Access Compliance Report

Public Rights-of-Way

Intersection ID: 52442	Main Street: WOODWARD_AV	Cross Street: BENDING_BIRCH_PL	Location: NW
ADA ID: 8A59A01E0C68	Ramp Type: Directional1	Initial Pass/Fail: Fail	Overall Compliance: No
			Severity Score: 13.75

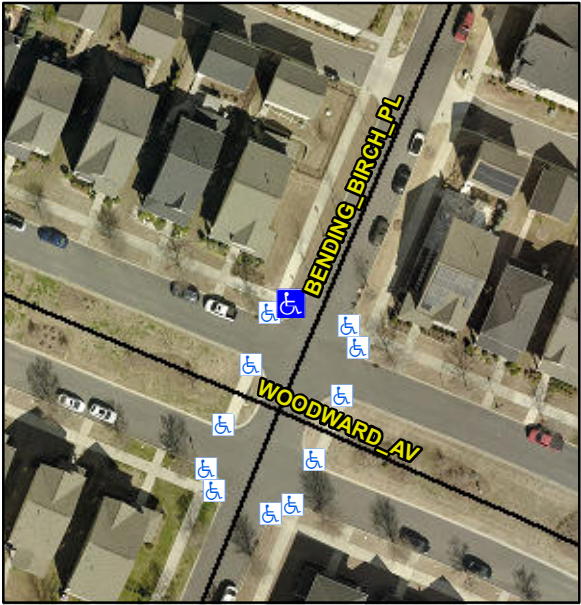
Codes/Mitigation Info/Possible Solution			Field Measurements/Component Compliance			
	Possible Solutions:		Compliance	Description	Data	
	Remove & Replace Entire Ramp.		N/A	Ramp Length (in)	76.5	N/A
			Yes	Ramp Width (in)	59.0	N/A
			No	Ramp Slope (%)	9.3	N/A
			No	Ramp XSlope (%)	4.1	N/A
			N/A	Flare Type LT	N/A	N/A
			N/A	Flare Slope LT (%)	N/A	N/A
			N/A	Flare Traversable LT?	N/A	N/A
			N/A	Flare Type RT	N/A	N/A
			N/A	Flare Slope RT (%)	N/A	N/A
Surveyor Notes: N/A			N/A	Flare Traversable RT?	N/A	N/A
			N/A	Landing Length (in)	0.0	N/A
			N/A	Landing Width (in)	0.0	N/A
			N/A	Landing Slope (%)	0.0	N/A
			N/A	Landing X Slope (%)	0.0	N/A
			N/A	Landing Curb? (Y/N)	N/A	N/A
			N/A	Shared Landing?	N/A	N/A
			N/A	Gutter Ponding?	0.0	N/A
			N/A	Gutter Lip Ht (in)	2.0	N/A
			N/A	Painted X Walk1?	No	N/A
PROW/ADA: R304.2.2, R304.5.3				X Walk 1 Direction	To E	N/A
				X Walk 1 Width (in)	N/A	N/A
				X Walk 1 Slope (%)	3.2	N/A

X Walk 1 X Slope (%)	4.5	N/A
			N/A	Ramp inside XWalk1?	N/A	N/A
			N/A	Any Obstructions?	N/A	N/A
				Obstruction Type		N/A
			Yes	Surface Condition? (G/P)	Good	Good
			N/A	Curb Slope (%)	3.7	N/A
Total Cost:		\$ 1600.00
